## Product Change Notification – Transparent Sleeves TM V0

#### **Sleeves of the type TM 201 V0 and TM 202 V0**

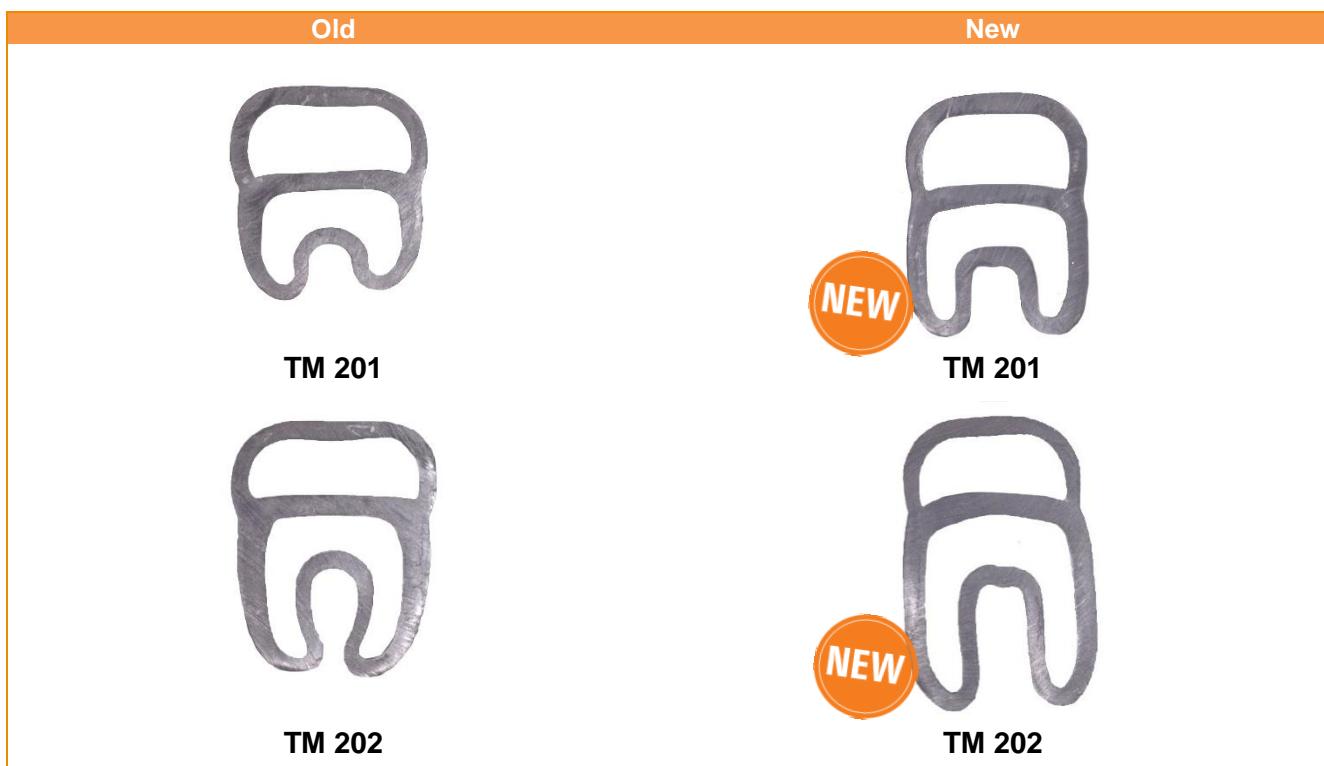
The technical change relates to the lower part of the TM 201 and TM 202 sleeves in which the wire is inserted. As shown on the following pictures the space available for the wire has been increased to facilitate wire insertion. In addition, the angular design of the inlay tag pocket allows the TM-I MultiCard and TM-I MultiMark inserts to fit perfectly.

The recommended conductor outer diameters do not change. Please note, however, that we can only guarantee perfect function for the following outer conductor diameters:

Type	Wire outside diameter
TM 201 V0	1,5 mm – 2,5 mm
TM 202 V0	2,0 mm – 4,0 mm
